ADDENDUM NO. 1

January 6, 2015

RE: **NCDOT Highway Division 14 – Macon County Rest Area, US-23/441,
Macon County, NC
SCO ID No. 14-11043-01A, TIP NO. K-5103**

PREPARED BY: Facilities Design, NCDOT

1 PARTIAL FLOOR PLAN

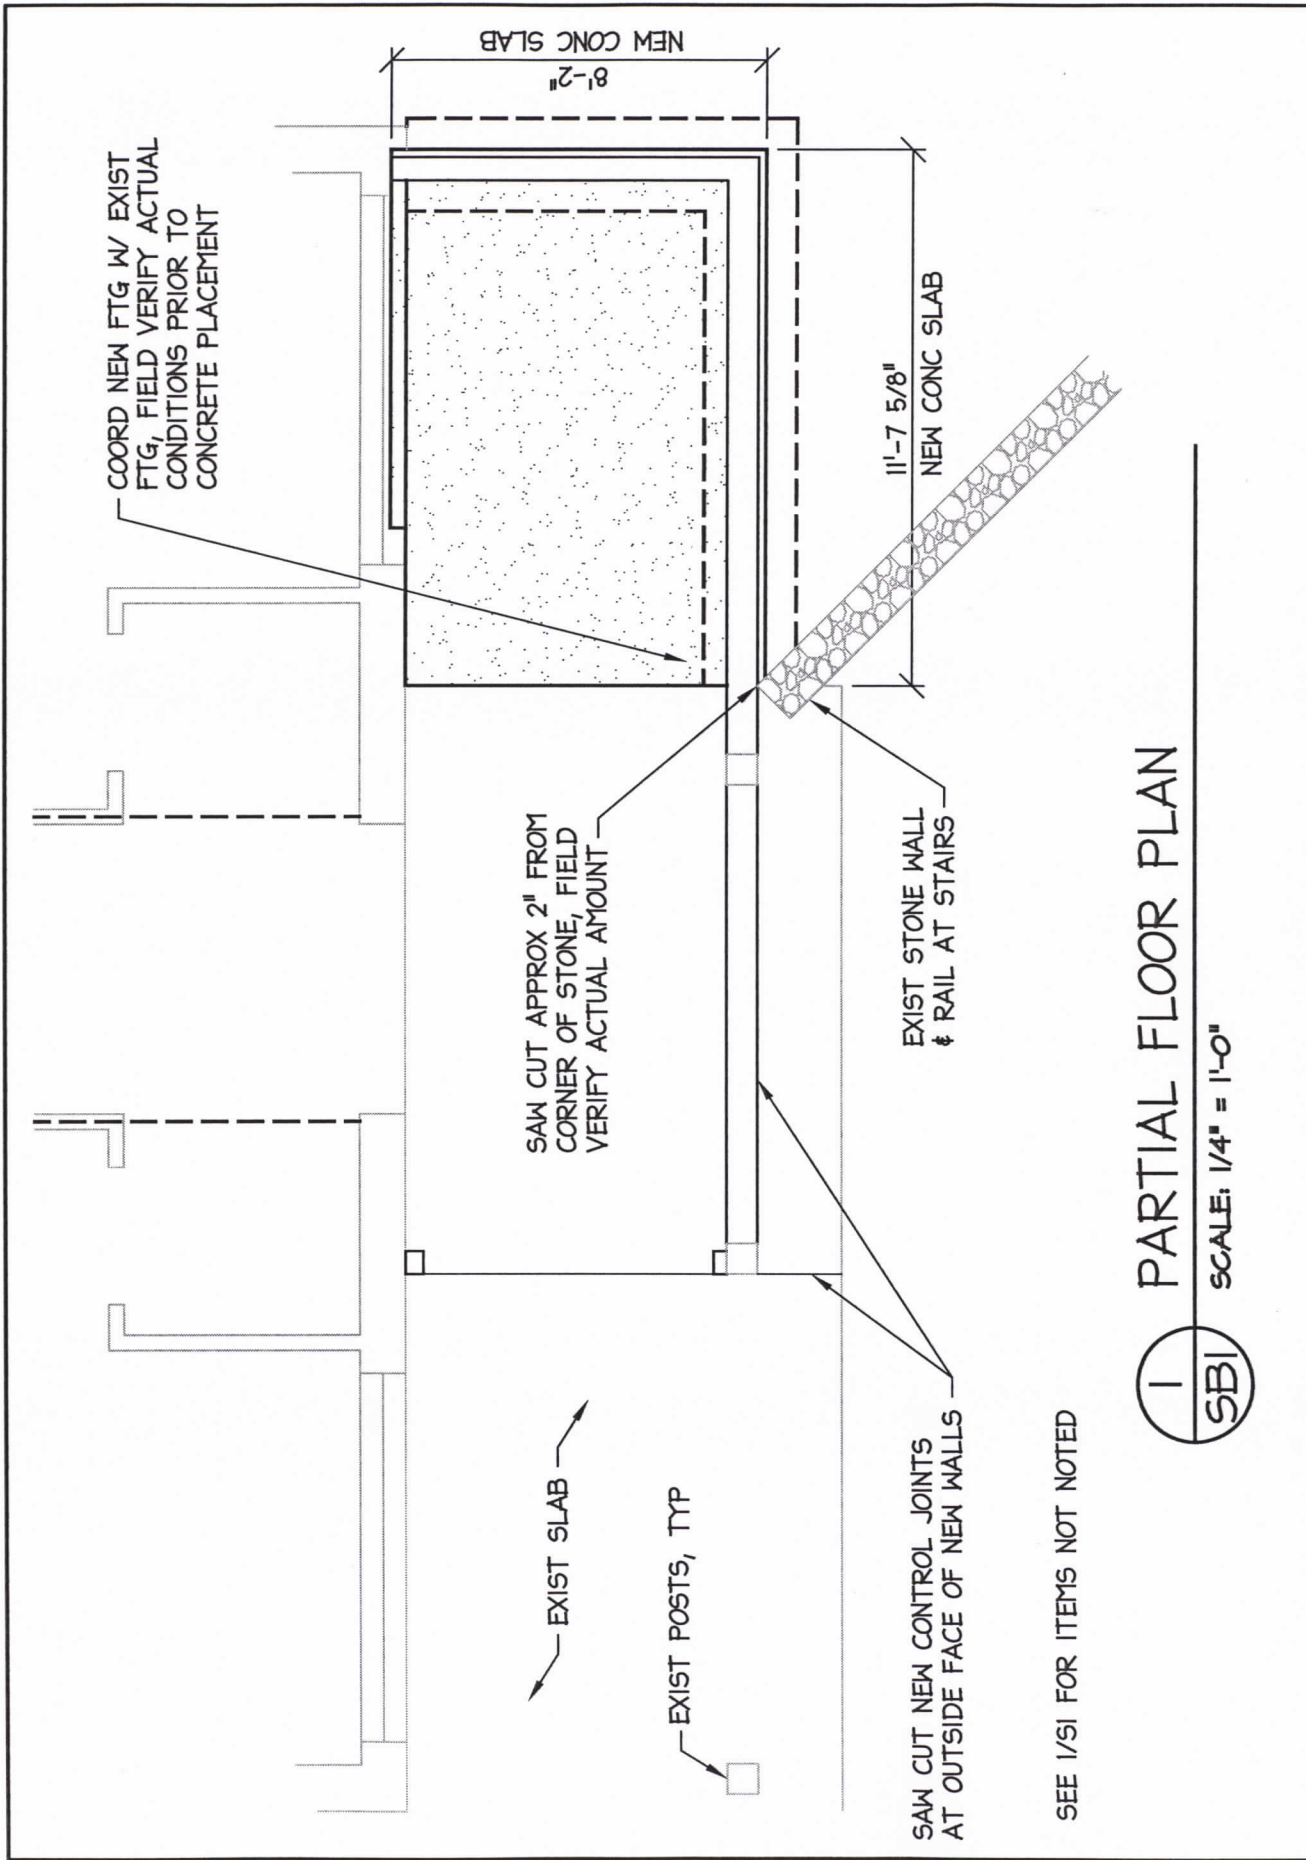
<u>Item</u>	<u>Sheet No.</u>	<u>Description:</u>
1.	S1.0	See attached Bulletin Drawing SB1, for notes on saw cutting and coordinating the new footing with the existing stone wall at the existing exterior stone stairs. Approximately 2" will need to be saw cut from the corner of the stone wall to allow the new exterior wall to be built.
2.	S1.0	<u>Notes:</u> Change Note 1. to read: "Concrete Strength for <u>footings</u> = 3000 Change Note 4. To read: "Floor slab shall be 4" thick concrete reinf. w/ 6x6-W1.4xW1.4 WWR on Min. <u>10 MIL</u> vapor retarder over 4" compacted granular base."
3.	A1.0	Demolition Key Notes- Add Note D-11:" Remove existing downspout (to right of Demo.Key Note D-6) and existing gutter above Demo. Key Notes D-4 and D-5."
